Harnett County Government Complex
307 Cornelius Harnett Boulevard
Lillington, NC 27546

Tingen Point
#08-5-20785 Lt 83
#08-5-20786 Lt 82

Re: Status of Improvement Permit Application

Lot # 83

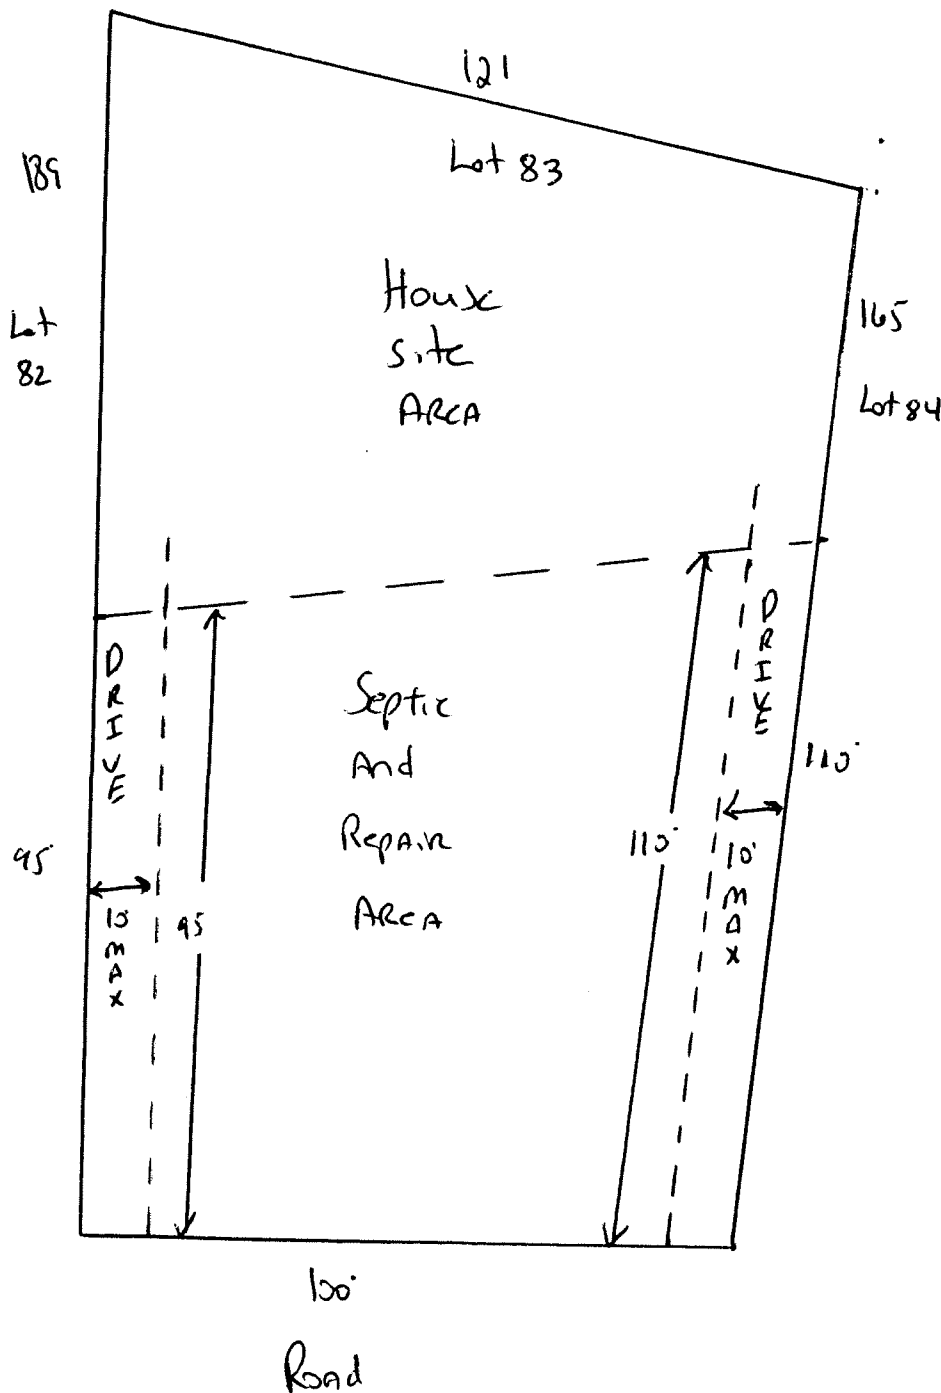
NOTE: That home must
be at least 95'
From Front property
Line (Along 82/83
Property Line) and
110' from Front property
Line (Along 83/84
Property Line)

NOTE DRIVE must
Be Along either
Property Line AS
Shown - DRIVE
To Be at a max
of 10' wide

Lot 82 Tinsjen Pointe

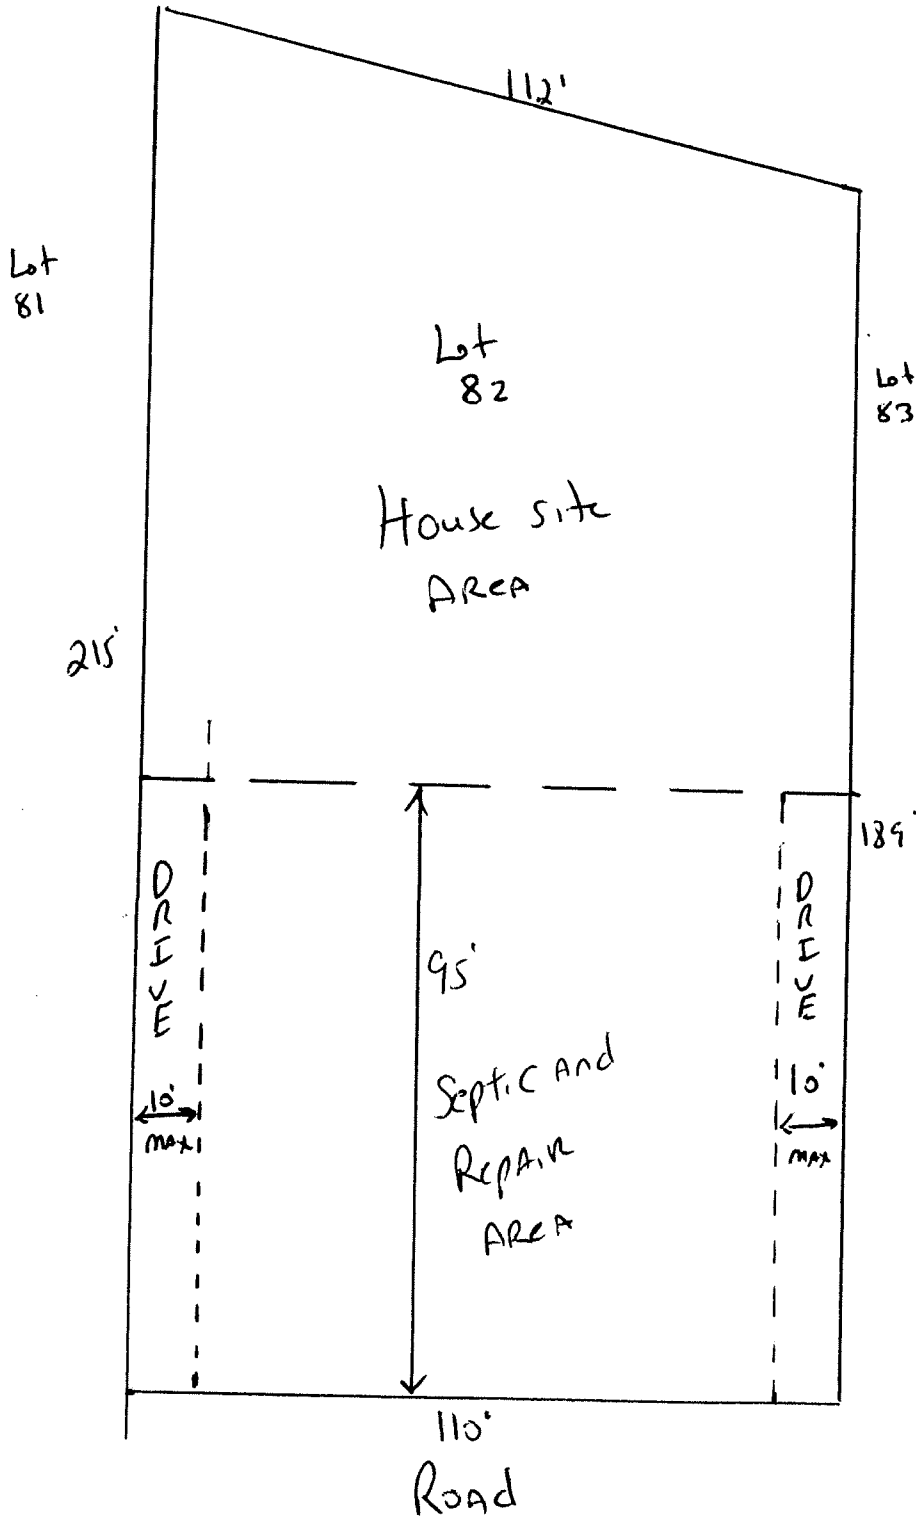
NOTE: Home must be
At least 95'
From Front
Property Line

DRIVEWAY can be
along either
Lot 81/82 Property
Line or Lot 82/83
Property Line
DRIVE TO BE A
MAX OF 10' wide
until DRIVE PASSES
95' from Front
Property Line
